**DECLARATION FOR THE  
SECOND EXPLANATION OF SIGNIFICANT DIFFERENCES  
DURHAM MEADOWS SUPERFUND SITE  
DURHAM, CONNECTICUT  
September 2018**

Durham Meadows Superfund Site  
Durham, Middlesex County, Connecticut  
EPA ID#: CTD001452093

**SECOND EXPLANATION OF SIGNIFICANT DIFFERENCES  
DURHAM MEADOWS SUPERFUND SITE  
DURHAM, CONNECTICUT  
2018**

**2018 ESD Figure 3**  
**SITE TCE CONCENTRATIONS IN GROUNDWATER IN BEDROCK AQUIFER**  
**COMPARISON OF PLUME IN 2005 TO 2016**

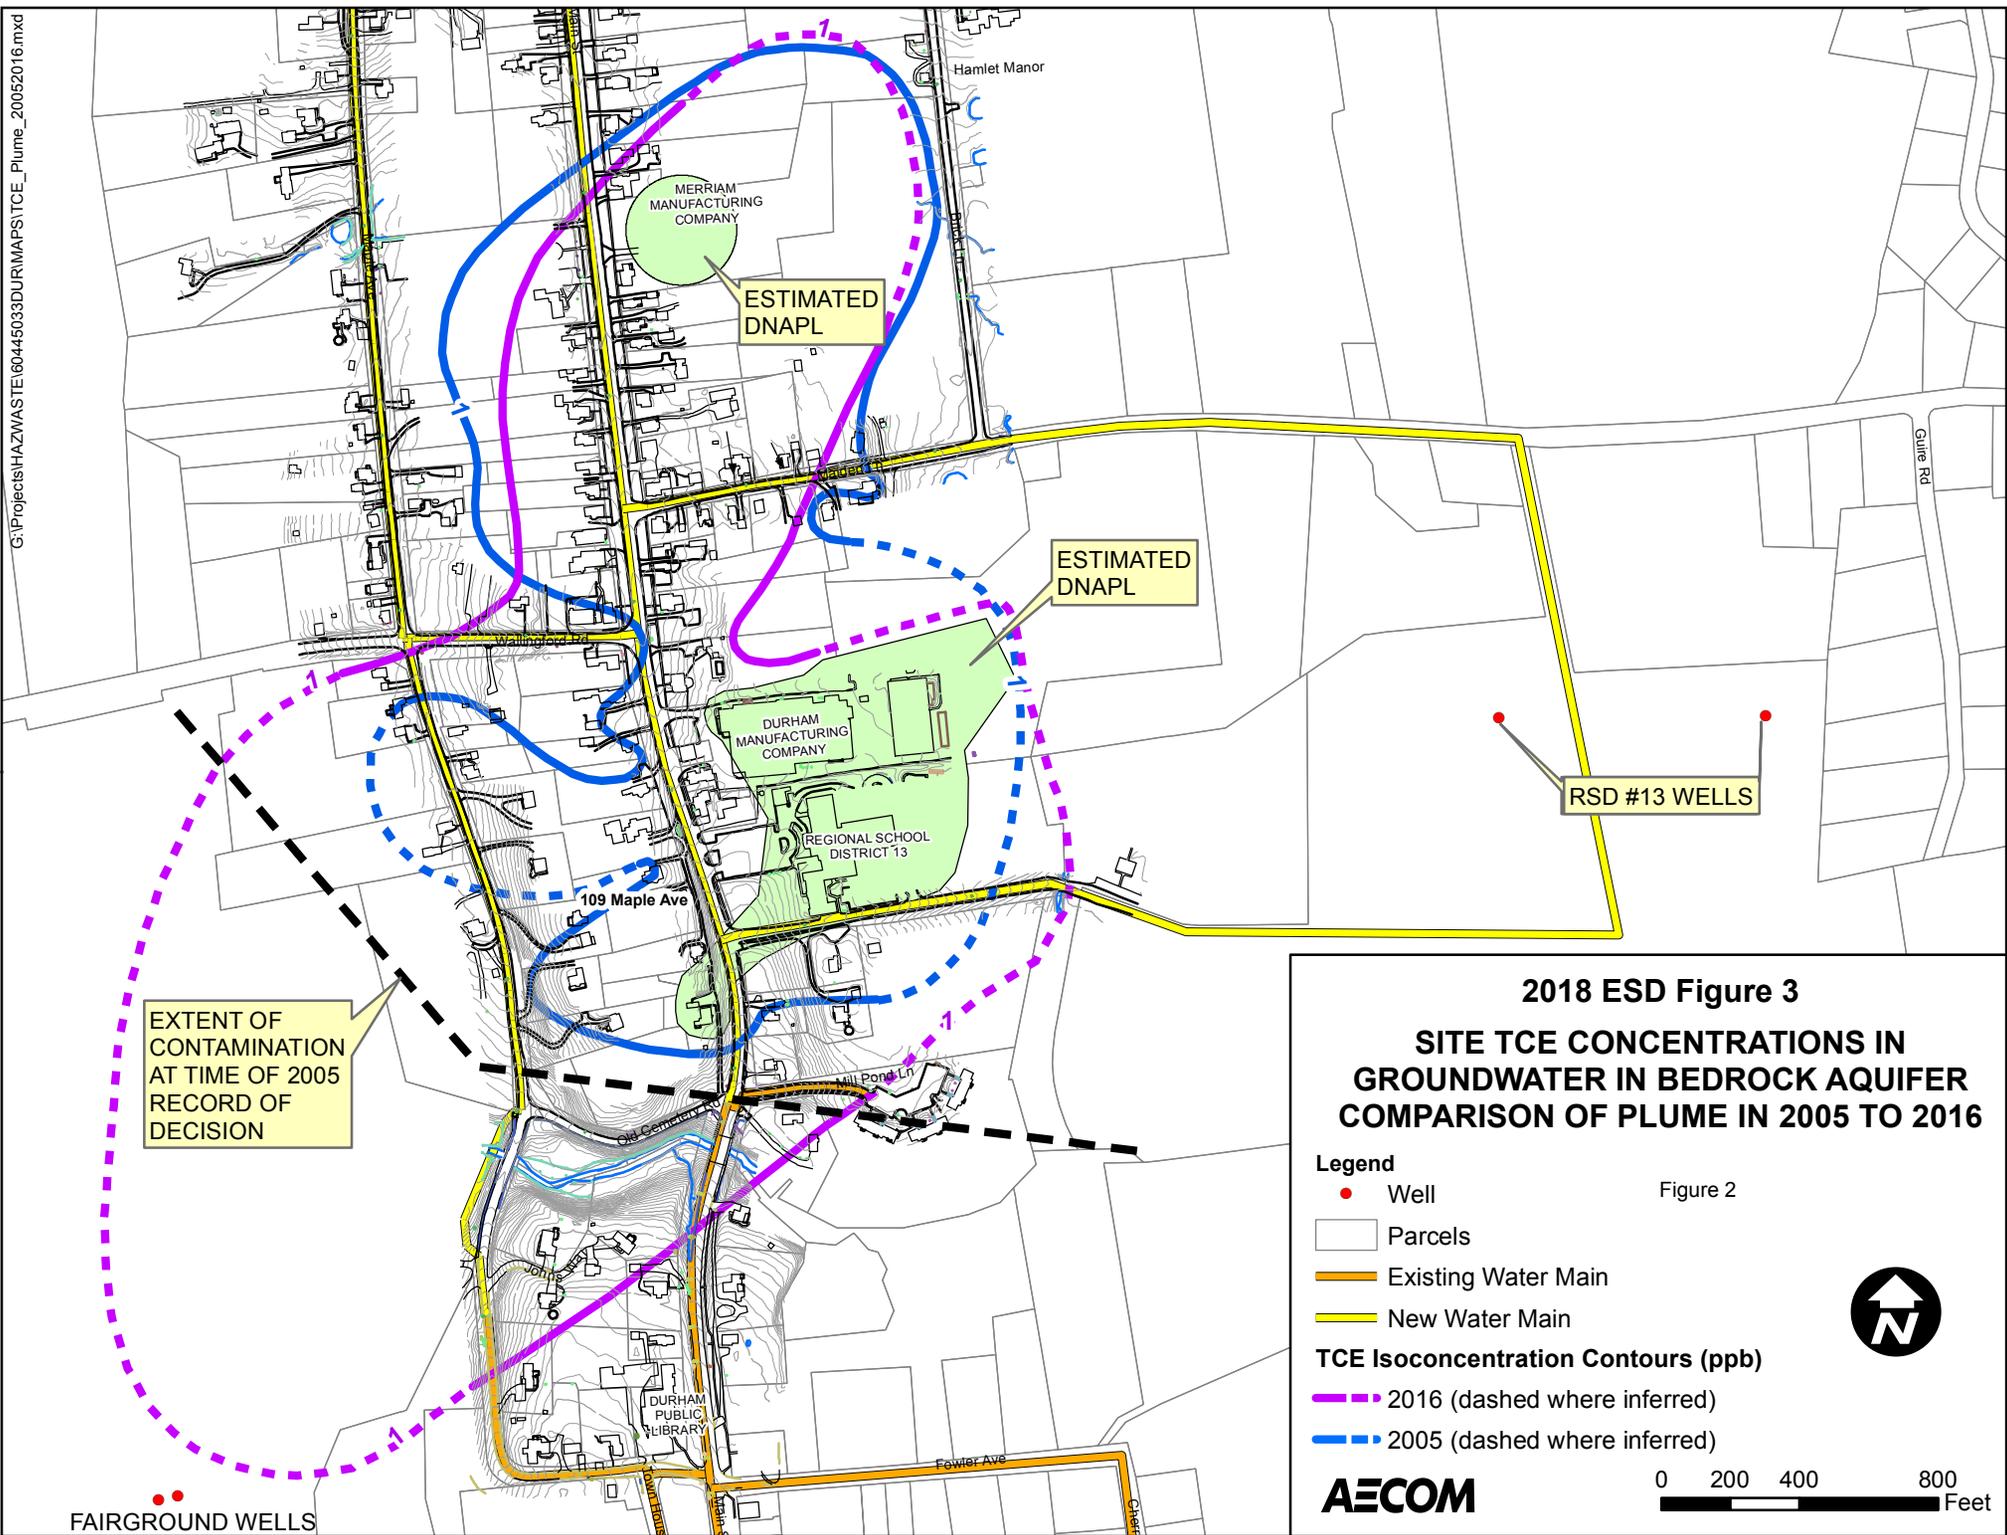
The 2005 ROD established a technical impracticability (TI) zone, which was the area where contaminated groundwater could not be restored and groundwater use restrictions would be implemented. At the time of the 2005 ROD, the southern edge of the contaminated groundwater plume and the associated TI zone did not extend south of Allyn Brook based on the assumption that Allyn Brook was a groundwater discharge boundary limiting the extent of contamination. However, in the fall of 2013, several residential wells south of Allyn Brook were added to the residential well sampling program in the DMC Study Area. In two of these well, TCE was detected at concentrations of 560 µg/l and 74 µg/l. Continued sampling of those wells in 2014 showed similarly high concentrations; as a result, when the extent of the contaminated

groundwater plume was updated and extended to the southwest, beyond Allyn Brook and toward the Fairground wells. The conceptual Site model has been modified to recognize that Allyn Brook does not constitute a discharge boundary that prevents plume movement beyond it to the southwest. Since no Site contaminants had been detected in the Fairground wells since they were put into service in the fall of 2007, the plume extent in 2014 was not drawn as far as those wells. The extent of the groundwater contamination at the Site is shown in Figure 2. The expansion of the groundwater contamination since the 2005 ROD is shown in Figure 3.

2018 ESD Figure 5  
 Durham Meadows Waterline RD  
 Schematic Drawing

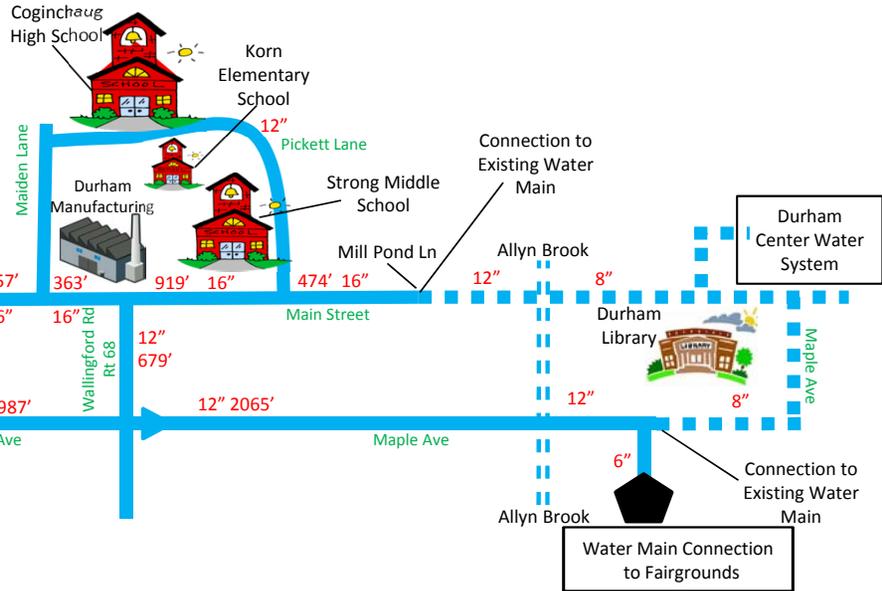
Figure 5 presents a schematic of the water line and associated features and Figure 6 shows the changes in the water line extent between the 2005 ROD and final design.

**Water Tank:** The City of Middletown provided comment on the 2005 ROD indicating that an atmospheric water tank would be necessary to provide water service to the Site because the Long Hill pump station had limited capacity. EPA indicated that this issue would be re-visited as part of the design. The design confirmed that the Long Hill pump station was inadequate to support the Site and that an atmospheric tank would be necessary. The water tank included in the Remedial Design was designed based on State of Connecticut Department of Public Health and City of Middletown Water and Sewer Department requirements.

**Booster Station:** Several residents of the City of Middletown are located in close proximity to the water tank included in the Remedial Design. The elevation of these residents' homes is too high to be served by the water tank, so they will remain on a hydro-pneumatic system similar to the one that currently supplies water to these residents at the Long Hill pump station. Because the hydro-pneumatic system is a closed pressure system and the atmospheric water tank is an open pressure system, the two systems cannot share the same water line. A design value engineering decision was made to relocate the hydro-pneumatic system to near the atmospheric water tank to use the existing water line. This eliminates the need to install 4,800 linear feet of additional water line to build a dedicated water main to feed the tank. The re-location of the booster station is more cost effective than constructing 4,800 linear feet of water line.

**Connection of RSD #13 and the Fairgrounds:** As part of the Remedial Design, EPA worked with the Town of Durham and CT DEEP to establish a groundwater restriction zone that would include the areas currently impacted by contamination and the areas where contamination could migrate in the future. Of particular concern was the migration of the contamination after all of the existing water supply wells cease operation because these wells could be limiting the movement of the contamination. The groundwater use restriction was finalized in 2015 and included the three public schools adjacent to the DMC property. One of these schools, the Strong Middle School, has a well that is contaminated and the decision was made to connect all three schools to the water line to prevent any future contamination of the other two schools' wells. In addition, the wells that support the Durham Fairgrounds are downgradient and appear to be in the path of the contaminant plume. As a result, the Remedial Design identified the Fairground Wells as wells to eliminate and required connection of the Fairgrounds to the water line.

**Additional Water Line Piping and Dimension:** The extent of water line has expanded to include the connection to the water tank, the RSD #13 public schools, Durham Fairgrounds and the extension of the water line down the entire length of Maple Ave. The 2005 ROD anticipated that the extent of Maple Ave north of Wallingford Road would be part of the water line. Since the 2005 ROD, groundwater contamination

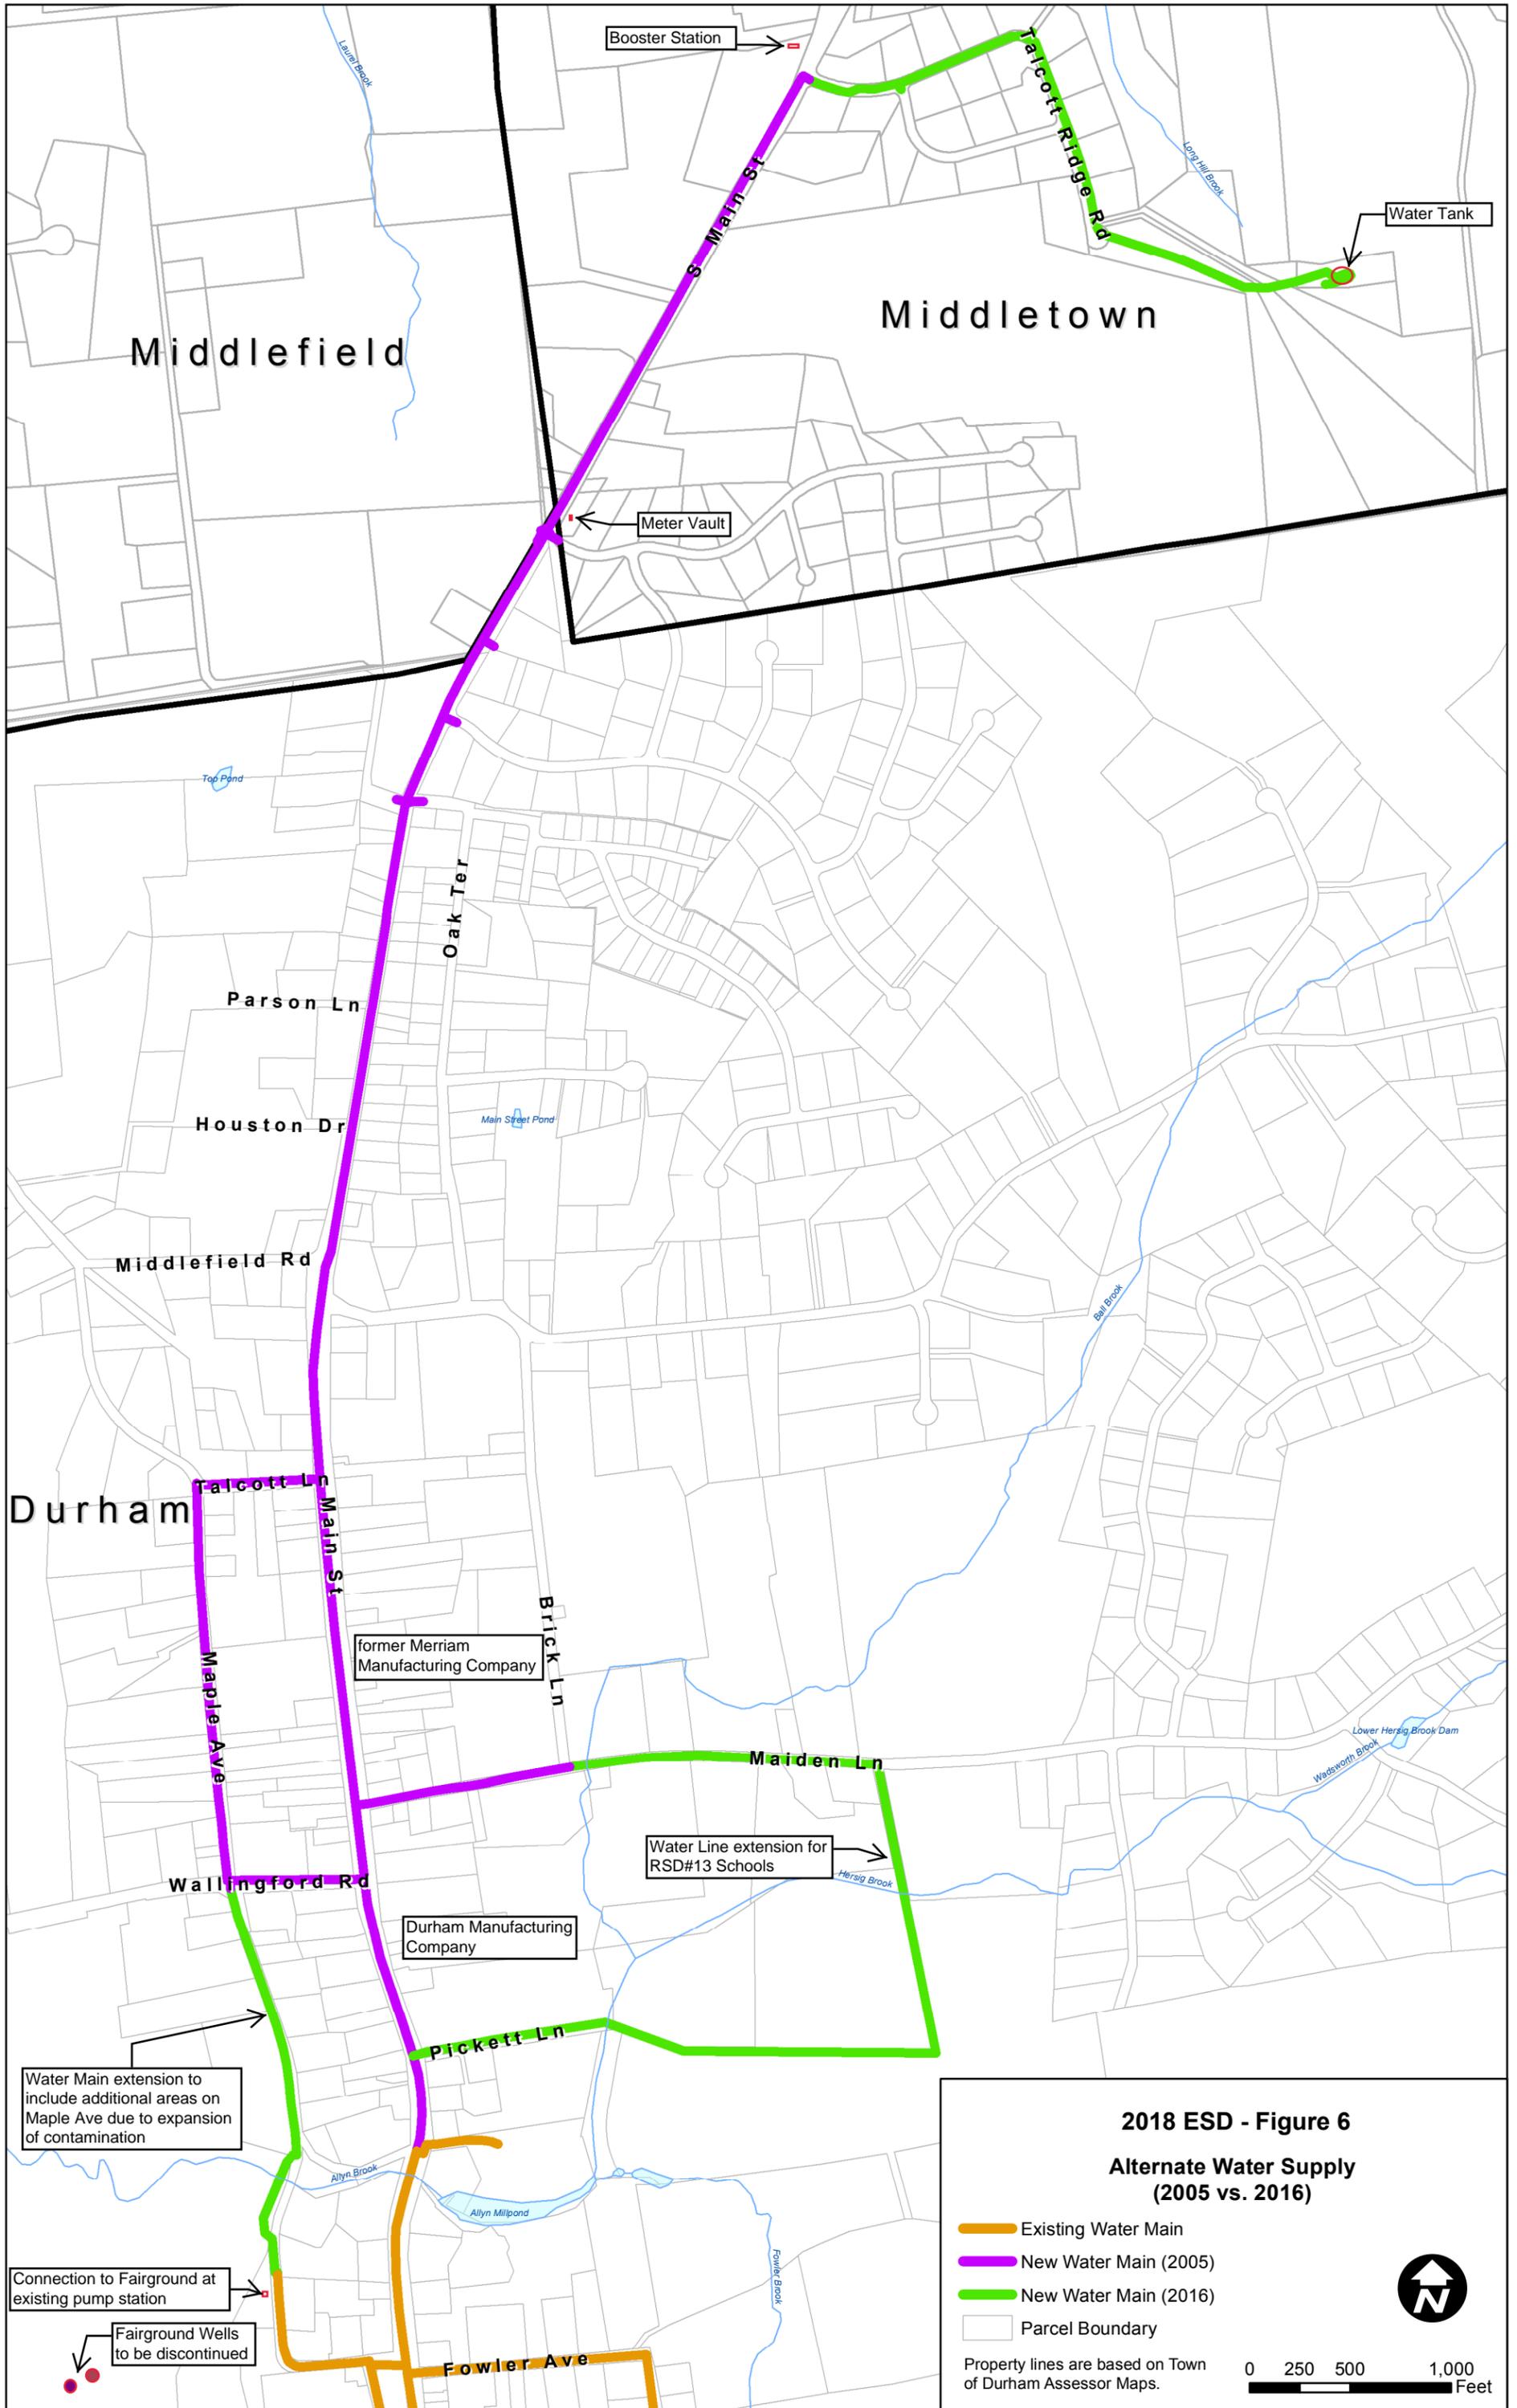
Water Main extension to include additional areas on Maple Ave due to expansion of contamination

associated with the Site has extended further south reaching John's Way and properties on Maple Ave south of Wallingford Rd. As a result, the water line has been extended to connect the area where the contamination has migrated. The water line size has also increased to address the additional flow requirements for the inclusion of the Fairground and RSD #13 Schools and to include flow for fire suppression at the RSD #13 Schools. The fire suppression at the RSD #13 Schools relies on the existing supply well which, pursuant to Connecticut Department of Public Health (CTDPH) regulations, must be abandoned once public water is connected. To allow RSD #13 Schools to maintain the existing fire suppression capacity, the water line size was increased to allow sufficient flow. The 2005 ROD included 15,400 LF of 6" water line, and the final Remedial Design includes 30,300 LF of water line ranging in size from 8" to 20".
